October 20, 1995

Subject: Response to Request for Additional Information on Individual  
Plant Examination Submittal, Davis-Besse Nuclear Power Station, Unit 1  
(TAC NO. M74402)

Figure 1-7. Event Tree for Sequences Initiated by a Small LOCA

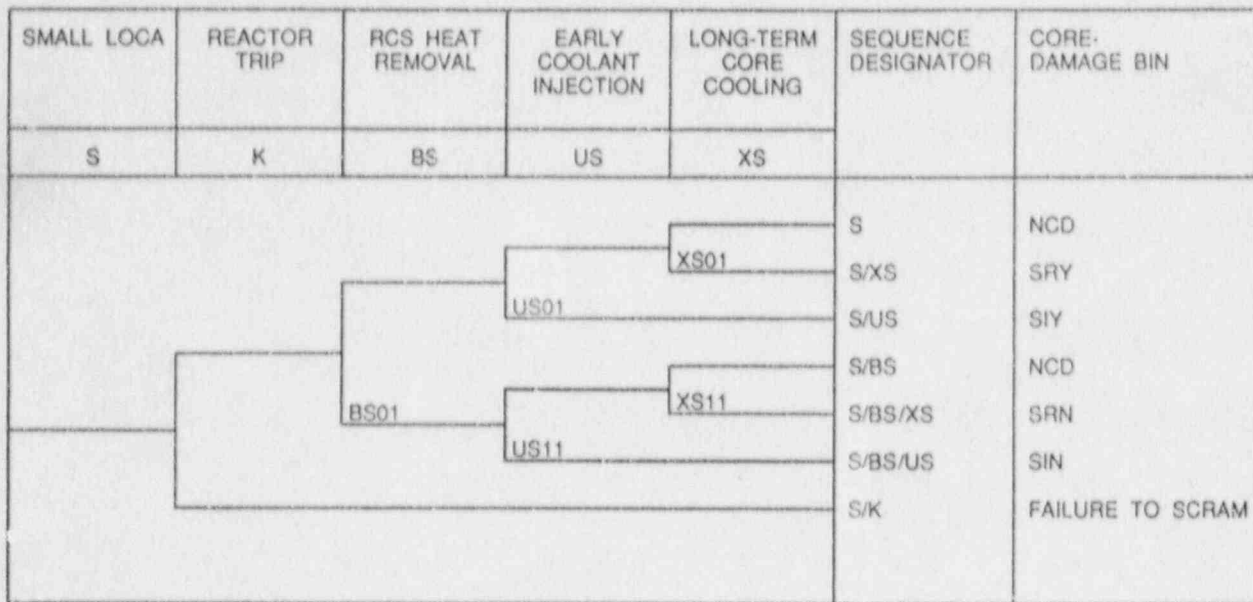
By letter dated September 11, 1995, (Toledo Edison Serial Number 2322) Toledo Edison (TE) responded to a Nuclear Regulatory Commission request for additional information (RAI) regarding the Davis-Besse Nuclear Power Station Individual Plant Examination (IPE). In responding to NRC Question 7 of the RAI TE inadvertently attached a transient event tree instead of the proper small Loss of Coolant Accident (LOCA) event tree (Attachment 3, Figure 1-7, to the RAI response). By attachment to this letter TE is providing the proper event tree for a small LOCA.
